Replies to Comment on bg-2021-10 by anonymous referee #1

This study estimated the tritium flux from rivers, Japan, and Fukushima Nuclear Power Plant after its incident caused by the tsunami in 2014 and during typhoon Hagibis and following typhoons in 2019.

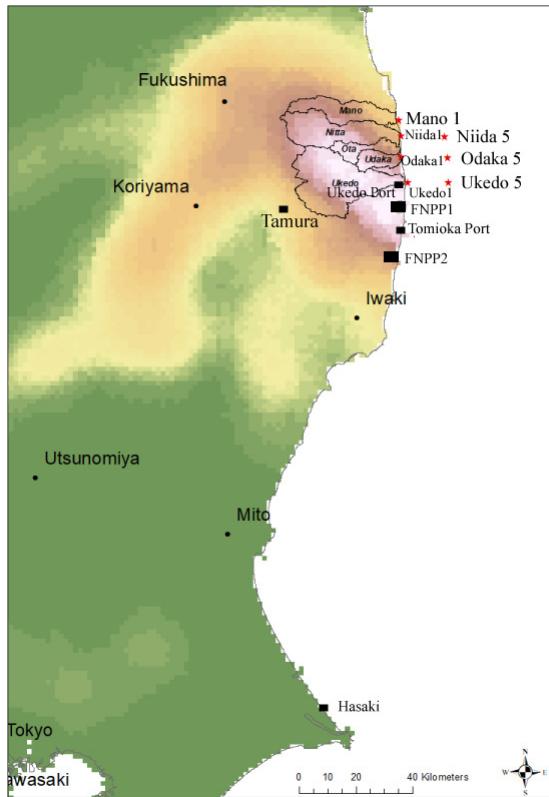
L120-121 “SoSo 5 rivers cruise and at the Tomioka port and Hasaki and discuss the behaviour of ${}^3\text{H}$ in the coastal region of Fukushima.”

Please specify. From figure 1, it is hard to find out where stations are. The authors should modify the station map of figure 1.

Reply: OK. The authors prepare a revised figure 1 as shown below. This figure will be further improved when the authors submit the revised manuscript.

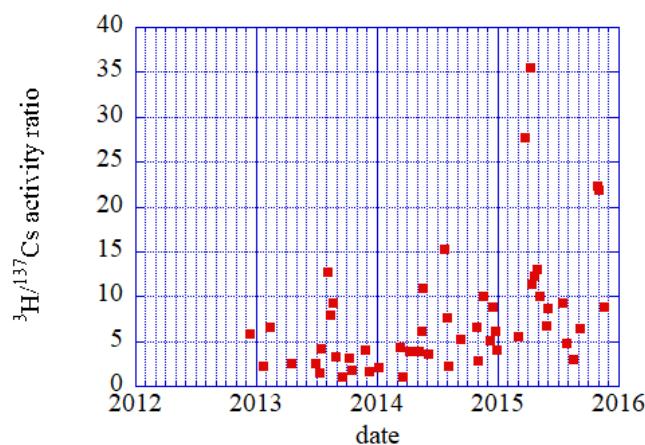
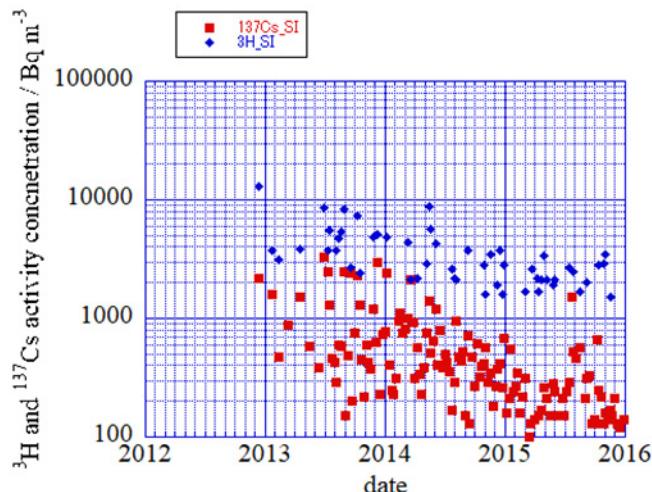
L250-254 “During.... 10 during the period from 2013 to 2016 (Figure are not shown).”

A figure showing the decline of the ratio with time is necessary. A detailed explanation of the reason is highly required because there could be process causing fraction between Cs and tritium during the water movement, other than the decontamination effort of TEPCO. Salinity change could also affect the ratio, however there were no description concerning the change in the ratio along the salinity gradient.

Reply: Ok, both ${}^3\text{H}/{}^{137}\text{Cs}$ activity ratio and their respective activities during the period 2012 -2016 are showed in figures below. ${}^3\text{H}/{}^{137}\text{Cs}$ activity ratio increase over time as mentioned in our text and not decline, while activity concentrations of ${}^3\text{H}$ and ${}^{137}\text{Cs}$ at 56N, shows a different decreasing trend.
